Dokorder, Inc.

SERVICE BULLETIN

SUBJECT: Model 1140 Replacement Circuit Board for
OUT OF WARRANTY REPAIR

NOTES ON THE 1140

Model 1140
Replacement of Bias PCB (PCM313E)
and Adjustment

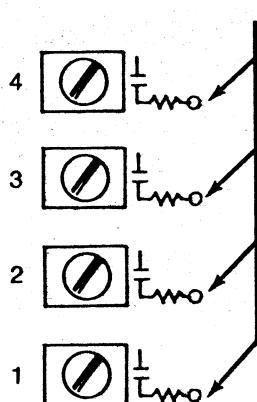
1. Remove bottom cover.
2. Remove mu metal shield surrounding bias board.
3. Remove four mounting screws.
4. Unplug 18 pin and 10 pin connectors. (Do not turn over!)
5. Plug connectors into new board, making sure that connections are same (top of connectors are not reversed).
6. Install four mounting screws (do not tighten).
7. Reinstall mu metal shield after adjustment.

1. Load unit with tape, bias in fixed mode, unit in record, pause on, multi-sync off, all channels in record.
2. With VTVM or scope, adjust bias trap coils for minimum reading (see below).

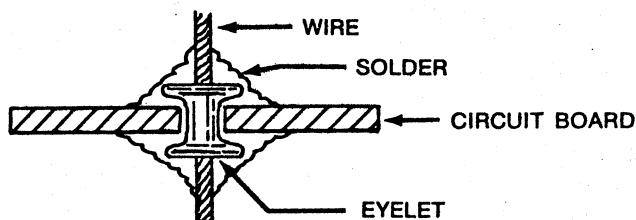
We have experienced intermittent connections in the following printed circuits:

Head Amp EQ
Bias Oscillator
Multi-Sync

Rather than repair the intermittent board, we are asking that you replace all boards as per the following instructions.

The intermittent connectios are the result of poor contact of an "eyelet" used to connect both sides of the circuit board (see below) to the solder.

The new boards have a wire through each eyelet, then soldered (see below).

If you replace the playback board PCM-342E (old type) with the PCM-418 (new type), a diode (SIB-0102) must be inserted in the small board (PCM-391) located next to the head amp.
